# SAFETY RECALL BULLETIN

## NHTSA RECALL 21V030

AUTOCAR, LLC SAFETY RECALL ACX-2101

Autocar has determined that a safety defect may exist in the routing of the seat belt wiring harness on certain 2018-2021 model year Xpeditor® vehicles. The seat belt wiring harness routing may be too close to the seat mechanism and may chafe, if the harness becomes chafed and short circuits, the circuit protection fuse will open, and the engine will shut off and not restart.

**Figure 1, Left Side Seat Belt Location**

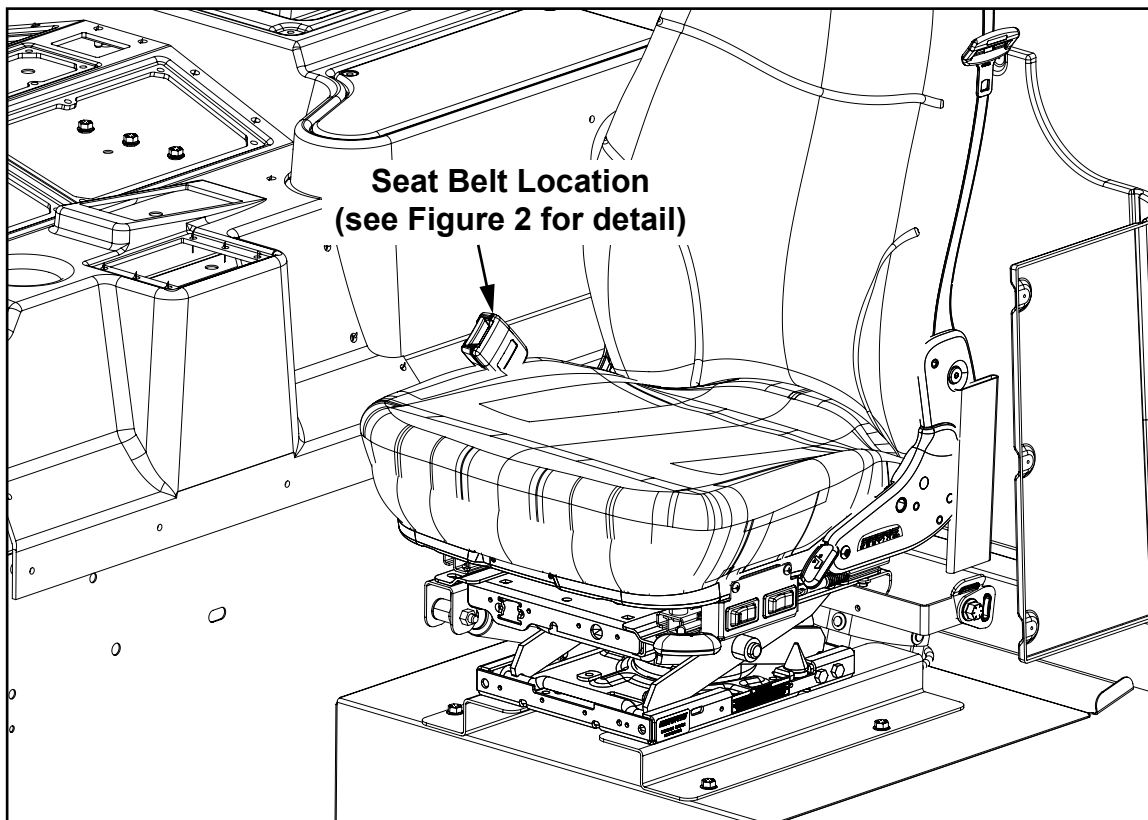
1. Follow all lockout/tagout procedures and verify the battery disconnect switch is in the “OFF” position. If the unit is not equipped with a battery disconnect switch, disconnect the battery cables beginning with the negative cables, follow by the positive cables.
2. Unlock and open the left door.
3. Locate the seat belt wiring harness and inspect for any chafing or damage (see Figures 1 and 2).

**Figure 2, Left Side Seat Belt Wiring Harness Routing Detail  
(Seat Removed for Clarity)**

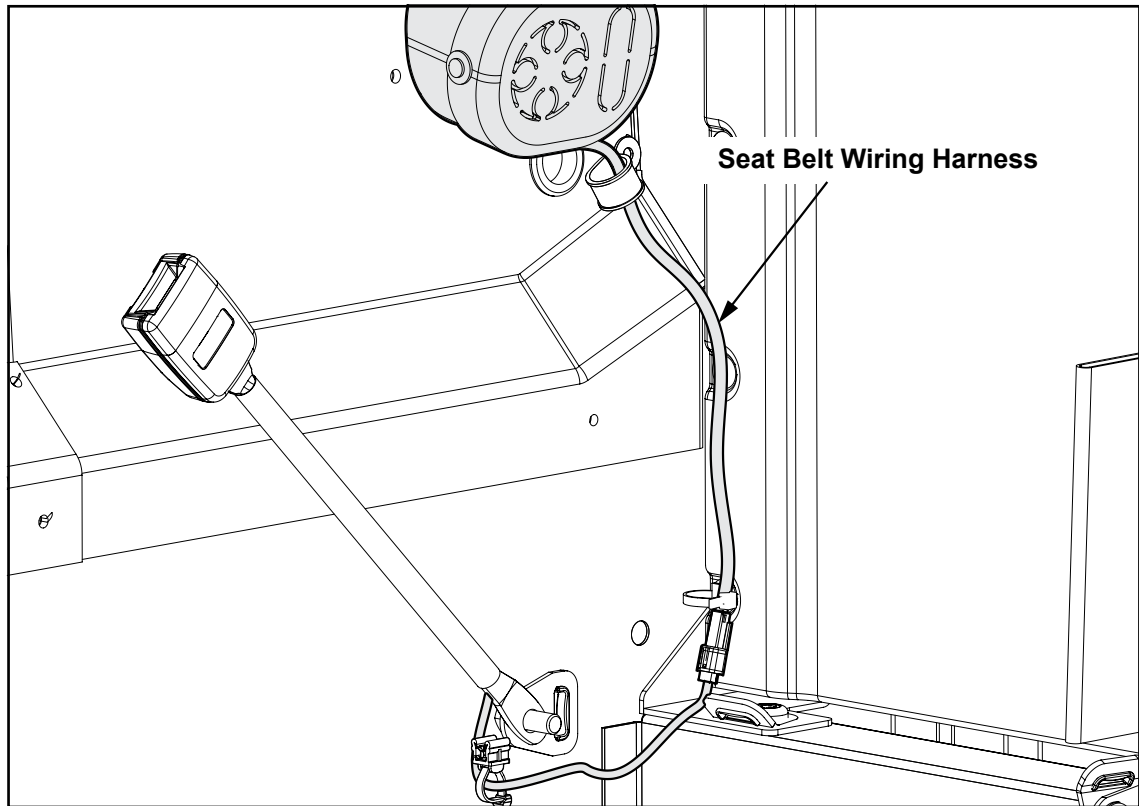
**Note:** If any chafing or damage is found, please contact Autocar Technical Support at 888-218-3611 for further instructions.

4. After any repairs are completed or if no damage is found, verify the routing of the seat belt wiring harness is as indicated or route and secure the seat belt wiring harness as indicated using cable ties obtained locally (see Figure 2).
5. For left drive units proceed to **Section III**.

**Figure 3, Right Side Seat Belt Location**

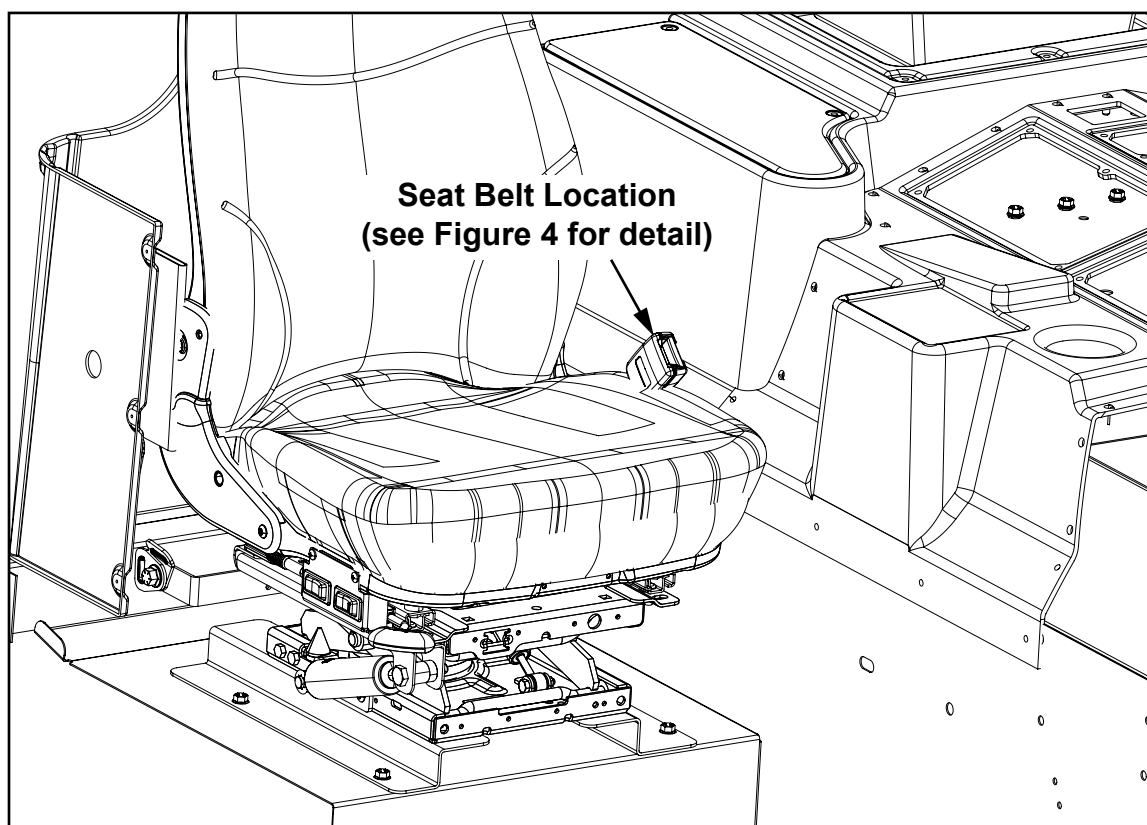
1. Unlock and open the right door.
2. Locate the seat belt wiring harness and inspect for any chafing or damage  
(see Figures 3 and 4).

**Figure 4, Right Side Seat Belt Wiring Harness Routing Detail  
(Seat Removed for Clairity)**

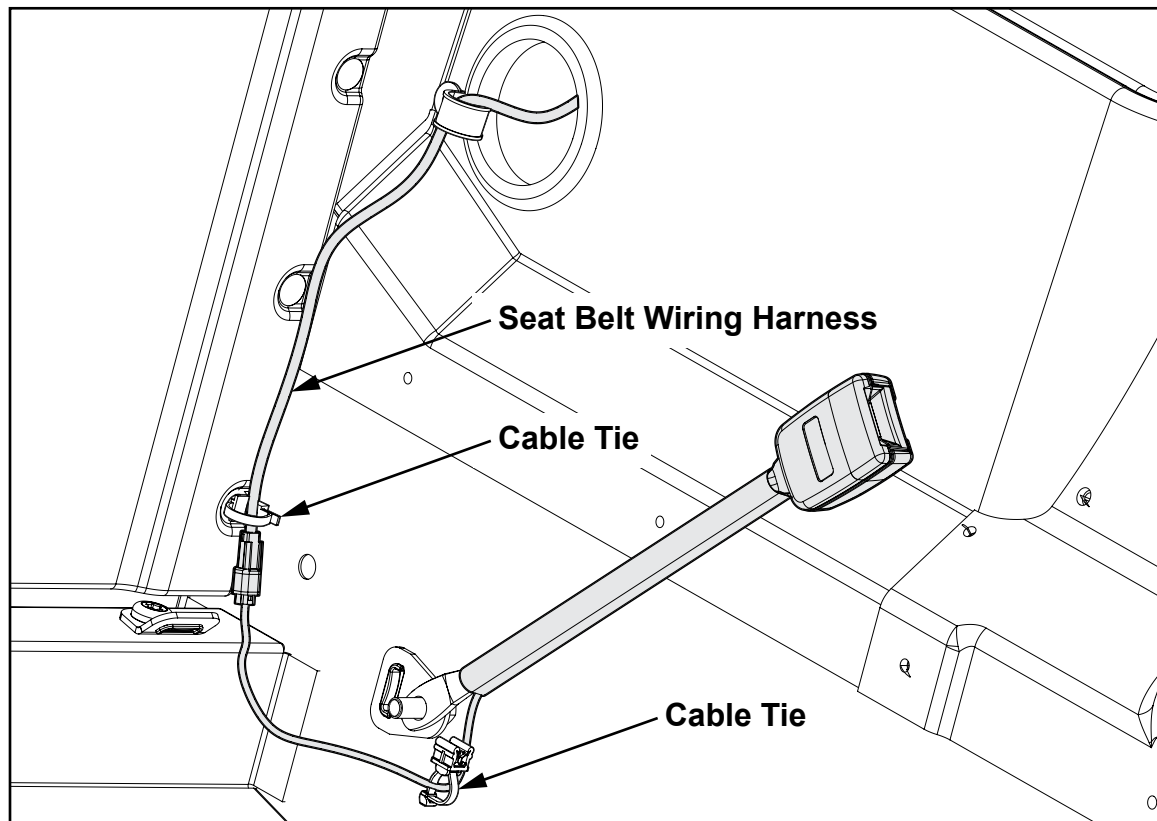
**Note:** If any chafing or damage is found, please contact Autocar Technical Support at 888-218-3611 for further instructions.

3. After any repairs are completed or if no damage is found, verify the routing of the seat belt wiring harness is as indicated or route and secure the seat belt wiring harness as indicated using cable ties obtained locally (see Figure 4).
4. Proceed to **Section III**.

**Figure 6, Dual Drive Mode Switch Location**

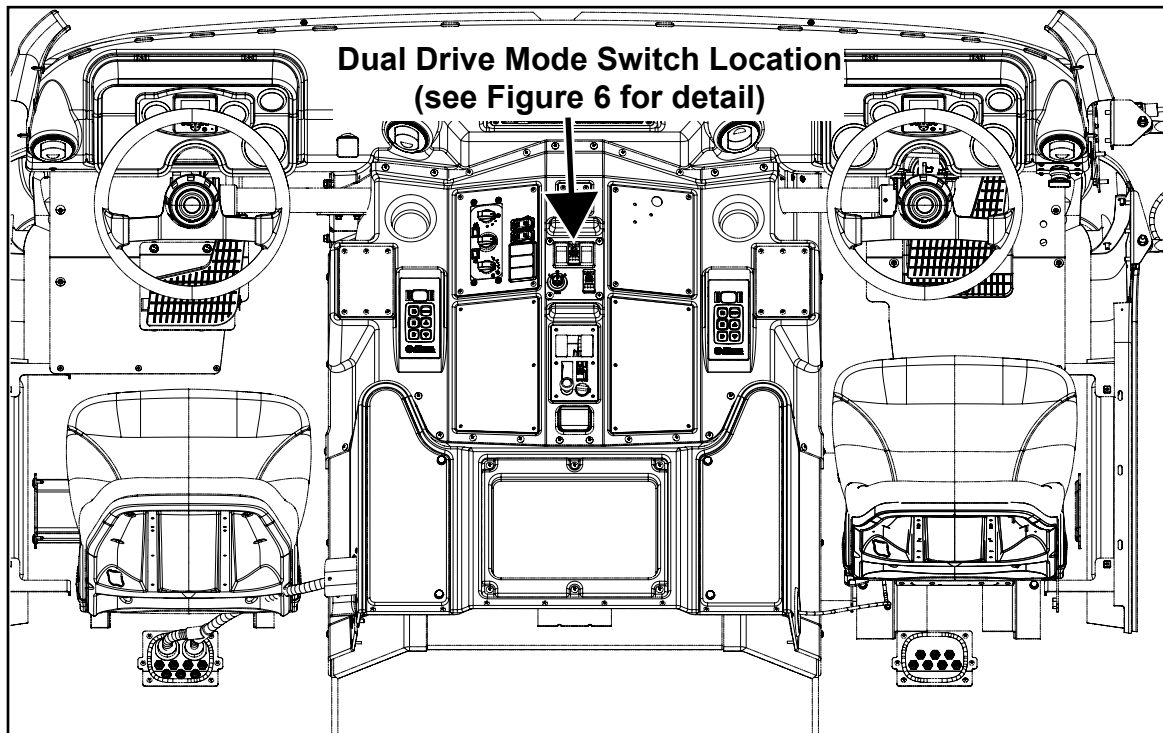
- 4 For dual drive position units: From either driver position, verify the drive mode switch is selected for the seating position to be tested, cycle the key switch to the on position (key on engine off) and observe the seat belt warning telltale. With the seat belt un-latched the telltale should be illuminated (see Figures 6 and 7).
